Arrow Energy -

Additional Information to support Hopeland Stage 2

Additional Information to support Hopeland Stage 2

The following document provides the response to the request for further information issued by the Department of Environment, Tourism, Science, and Innovation (DETSI) on 18 May 2026 in regard to the amendment requested by Arrow Energy to the Hopeland Environmental Authority (EA) (EA0001401).

Figure 1 - Plot plan of the Chinchilla Demonstration Facility showing the locations of Gasifiers 1 to 5 (from Perkins, 2018)

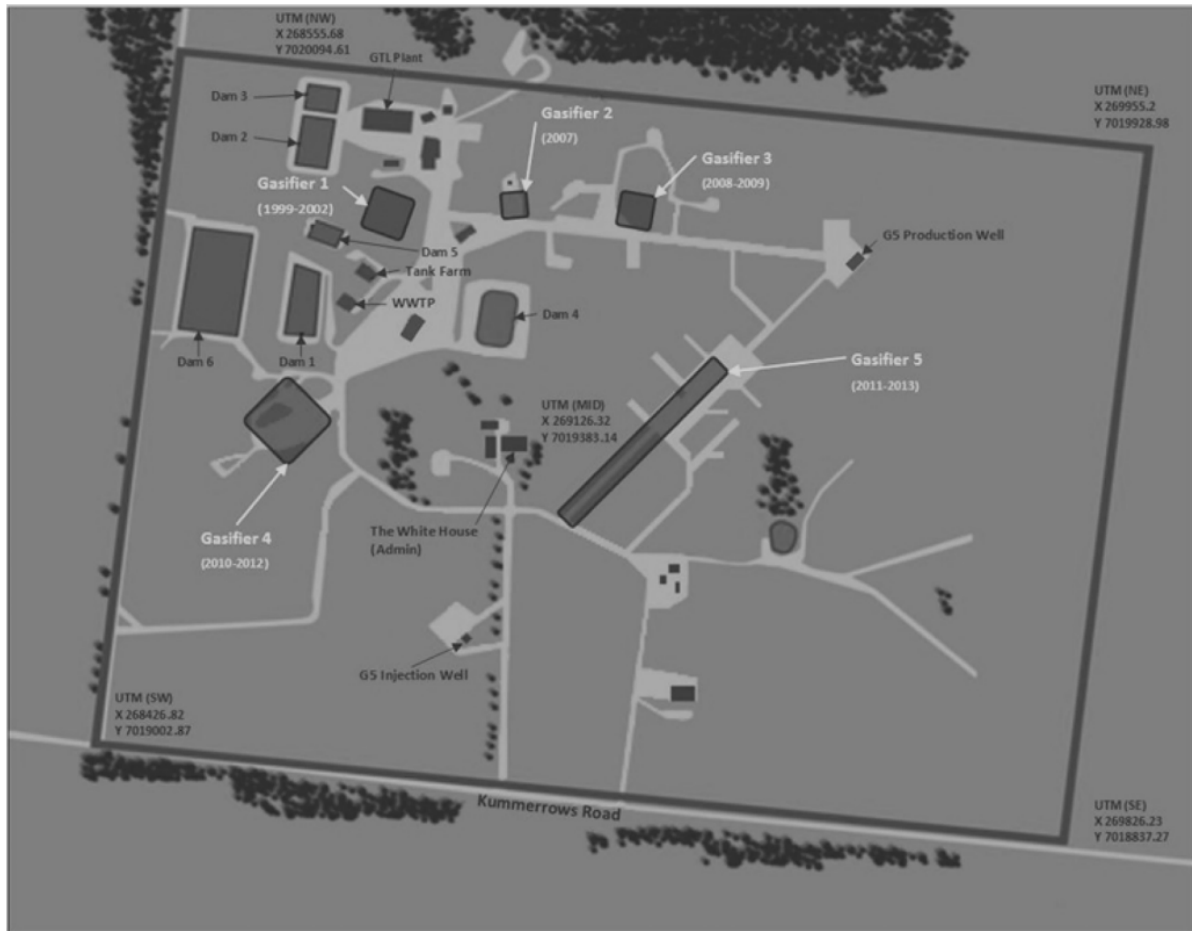
Issue 1: What is size of the Gasifier void/s at the Linc Energy Site?

The size of each gasifier was informed from Perkins^[1] (2018) map (shown in Figure 1 below) and intercepted by the model cells as shown in Figure 3-5 of the model report. The simulated area of each gasifier is as follows:

- G1 = 10,981 m² operated from 1999 to 2002
- G2 = 6,039 m² operated in 2007
- G3 = 8,236 m² operated from 2008 to 2009
- G4 = 10,432 m² operated from 2010 to 2012
- G5 = 27,452 m² operated from 2011 to 2013

AECOM (2018) calculated the gasifier volumes as burn cavities which has been created due to UCG process:

- G1 = 10,000 m³
- G2 = 500 m³
- G3 = 1,700 m³
- G4 = 9,000 m³
- G5 = 12,000 m³

Figure 2 – Northwest-southeast cross-section of HSUs, groundwater levels and concentration at the end of 2025

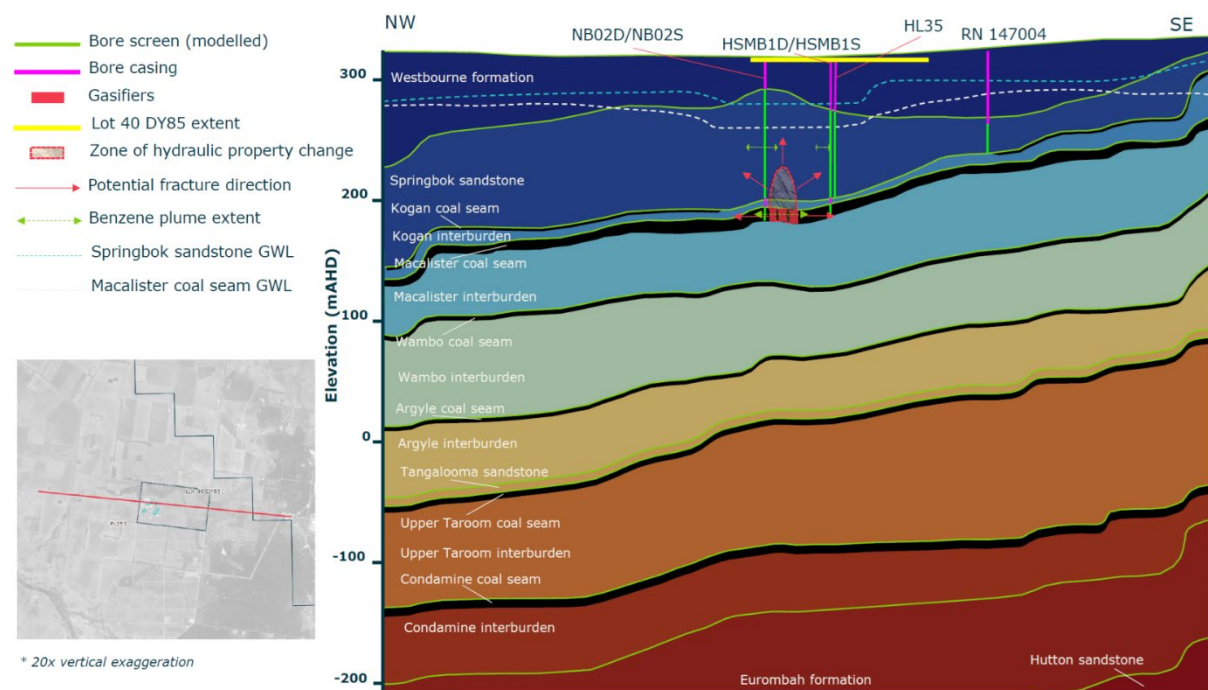
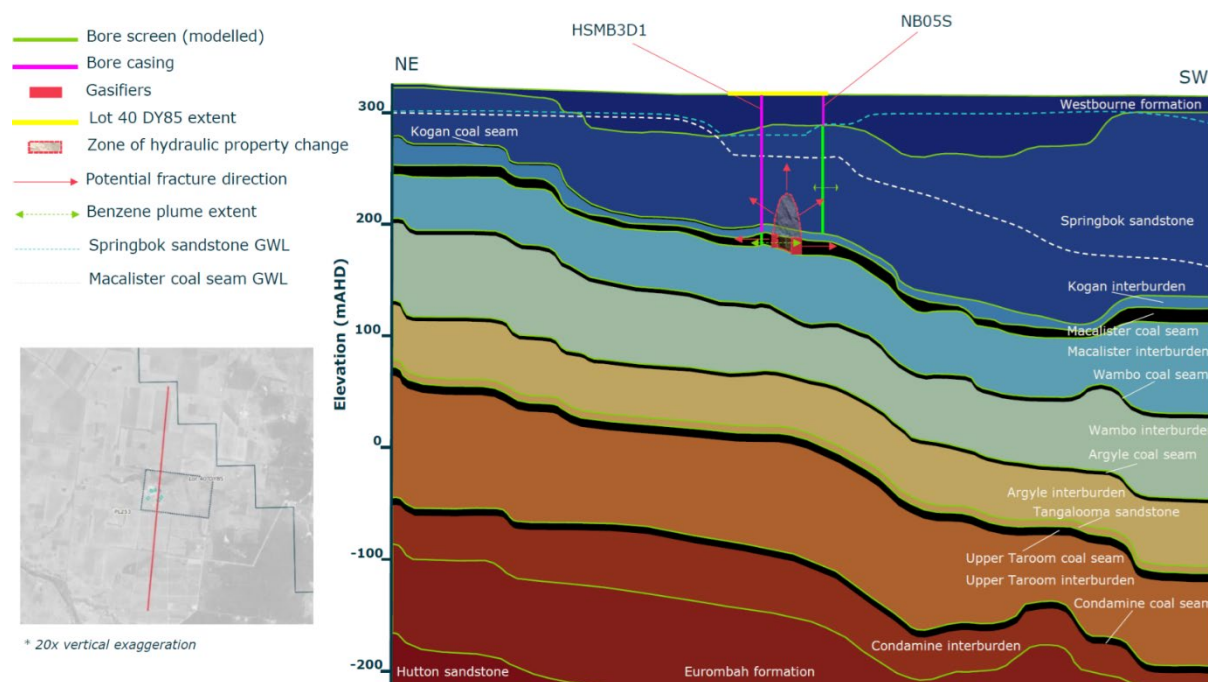
Issue 5: Poor cross-sectional display of the conceptual model diagram (figure 2-1). CSM display needs to be improved. The conceptual model should display void at the Linc Site, site boundary, major hydro-stratigraphic units, monitoring wells, current hydraulic head in the monitoring well (in mAHD), current plume extent and key groundwater receptors (e.g. water

supply wells). A minimum of two cross-sections (one east-west and another north-south) would be required.

Two cross-sections (Figure 2 and Figure 3) have been added to expand on the conceptual site model (CSM) presented in Section 2.1 of the EA amendment report.

The cross-sections explicitly incorporate the legacy of UCG operations. Note that the initial contaminant placement at the Linc site did not occur via groundwater flow, but rather through high pressure, high temperature gas-phase migration and subsequent condensation within and adjacent to the gasifier voids. This is consistent with the site conceptualisation, where UCG operations (1999–2013) resulted in hydrocarbon by-products being introduced into surrounding strata under elevated pressure and temperature conditions, with associated fracturing and disturbance of overlying units (Section 2.1 of the report). To reflect this, the cross-sections (Figure 2 and Figure 3) include:

- The gasifiers and overlying altered zone, representing thermally and mechanically modified strata with changed hydraulic properties due to UCG-induced fracturing and material removal (consistent with Section 3.1.3.7 of the report),
- Major hydro stratigraphic units (18 layers represented in the groundwater model, consistent with Section 3.1.2),
- Monitoring wells, with current hydraulic heads (mAHD) based on end 2025 conditions (consistent with Section 2.4.1),
- The current plume extent, which reflects initial contaminant placement mechanisms (gas-phase migration and condensation during UCG operations) and attenuation, and
- Key groundwater receptors (e.g. landholder bore RN147004).

Overall, Figures 2 and 3 integrate the EA amendment CSM (Section 2.1 of the report), including the gasifiers, altered zone, hydrostratigraphy, monitoring data (heads), plume extent, and receptors (see also answer to question 9 below on potential groundwater receptors).

Figure 4 – Median groundwater levels around Lot 40 DY85 in the Springbok sandstone

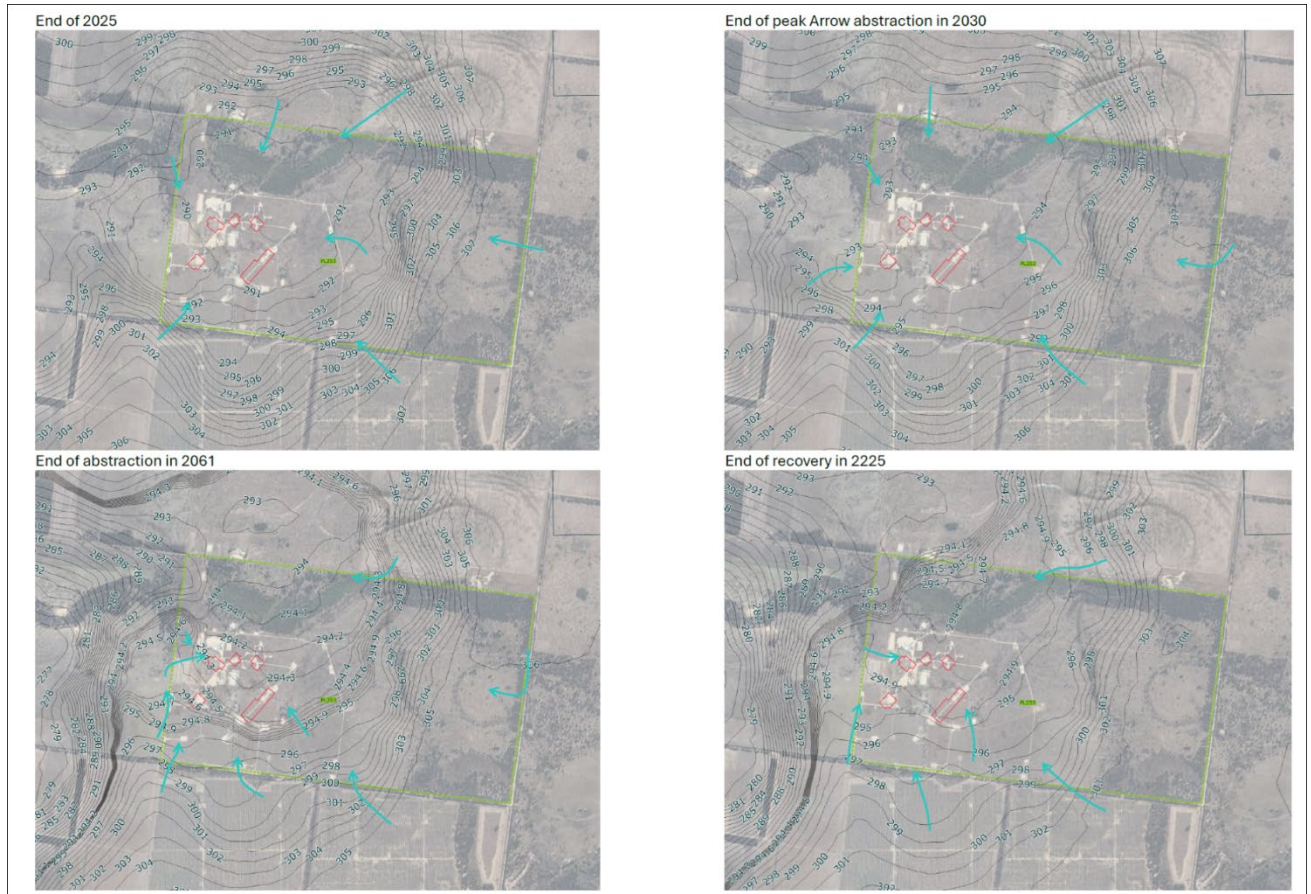
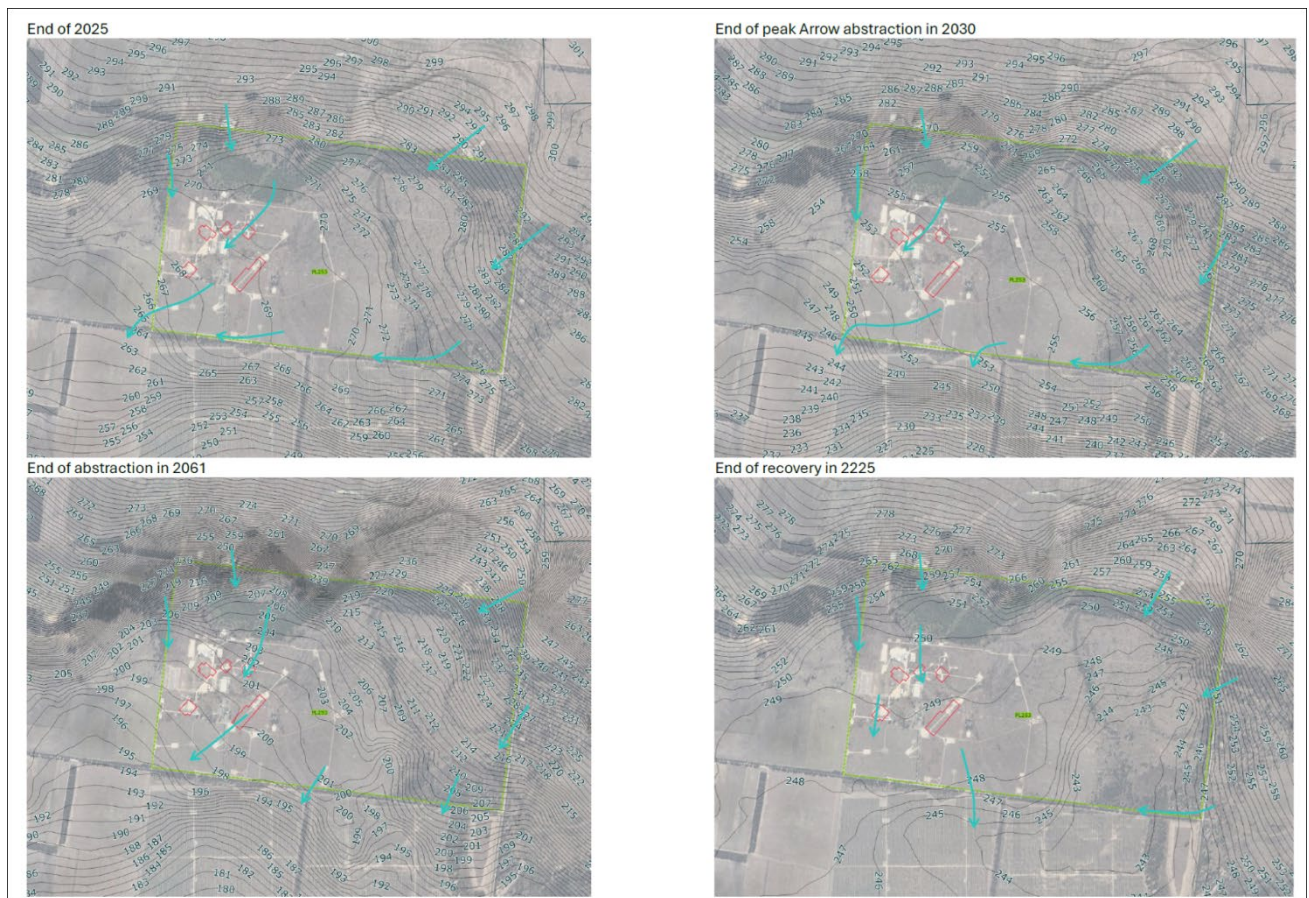
Issue 11: Timing of horizontal hydraulic gradient reversal has not presented in the report.

To assess the timing of horizontal hydraulic gradient reversal, median groundwater level contours for the Springbok sandstone and Macalister coal seam, constructed using simulated groundwater levels, were presented across the posterior ensemble at selected times during the abstraction and recovery periods (Figure 4 and Figure 5). Flow reversal was identified where outward hydraulic gradients developed along a substantial portion of the Lot 40 DY85 boundary.

In the Springbok Sandstone (Figure 4), inward flow toward Lot 40 DY85 persists through to the end of the recovery period (2225). This is due to the vertical flow direction between the Springbok sandstone and the underlying Macalister coal seam (near historical gasifiers) driven by CSG abstraction and ongoing recovery within the WCM.

In the Macalister coal seam (Figure 5), model results indicate that flow reversal occurred prior to 2026, consistent with recent observed groundwater levels. Groundwater flow enters Lot 40 DY85 from the northern and eastern boundaries and exits at the southwestern corner. From the end of peak abstraction (2030) through to the end of the recovery period, the direction of flow leaving the site shifts progressively toward the south.

Figure 6 - Predicted vertical hydraulic gradient between the Macalister coal seam and Wambo coal seam at paired monitoring locations

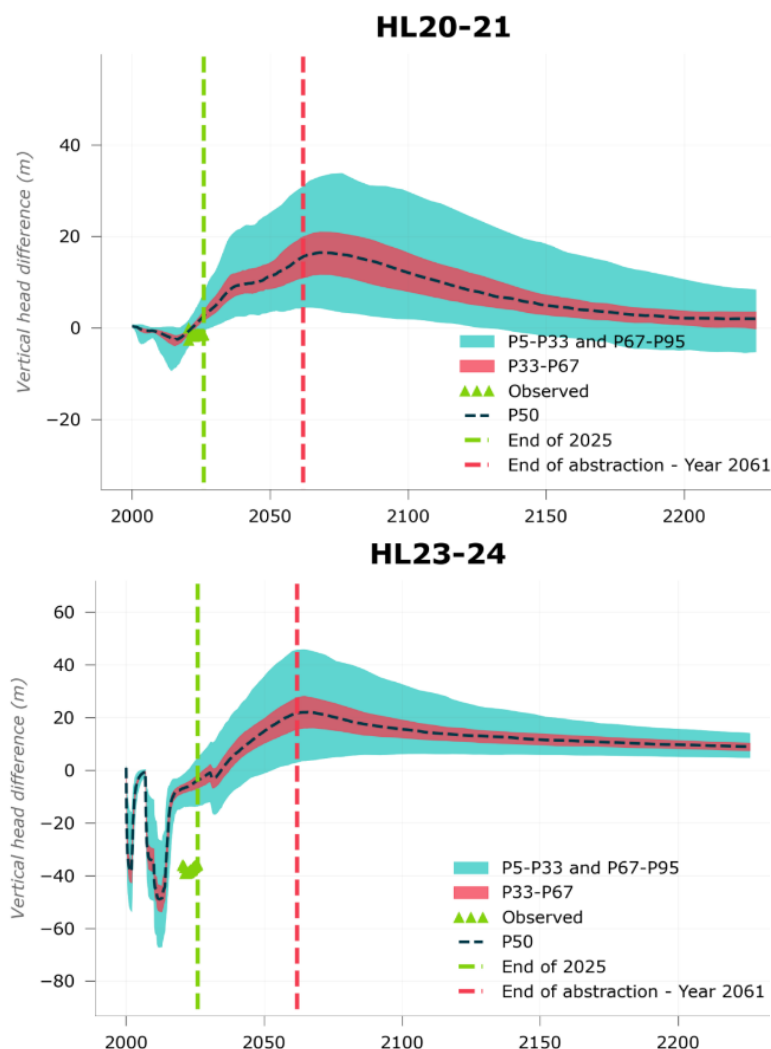
Issue 12: As per the report, the vertical gradient reversal is not expected in between the McAlister Seam and Springbok. What about the vertical gradient between the McAlister Seam and the underlying formation?

To further assess the vertical gradient between the Macalister and Wambo coal seams, simulated vertical head differences are presented for three distinct phases: pre-development (pre-2026), production/depressurisation (2026 to approximately 2060), and post-closure recovery (post-2060) for the monitoring bore pairs (Figure 6).

During the pre-development phase, the simulated vertical head difference remains negative, consistent with observed data, confirming an upward gradient from the Wambo coal seam to the Macalister coal seam. This agreement indicates that the model is satisfactorily calibrated and capable of reproducing the existing flow regime.

Following the commencement of CSG extraction from the coal seams in 2026, the model predicts a rapid transition to a positive vertical head difference. This indicates a reversal of the natural gradient, with a downward hydraulic gradient from the Macalister coal seam to the Wambo coal seam during the production phase. The largest head differences, and therefore the strongest downward gradients, occur during the mid-production period, as demonstrated by the HL20–HL21 and HL23–HL24 bore pairs. This reversal of hydraulic gradient in the coal seams is also observed by OGIA:

During the post-closure recovery phase (post-2060), simulated vertical head differences gradually decline toward zero. This suggests a progressive weakening of the induced downward gradient, with the potential for the system to approach near-equilibrium conditions and, depending on recovery rates, partially re-establish the natural upward gradient.
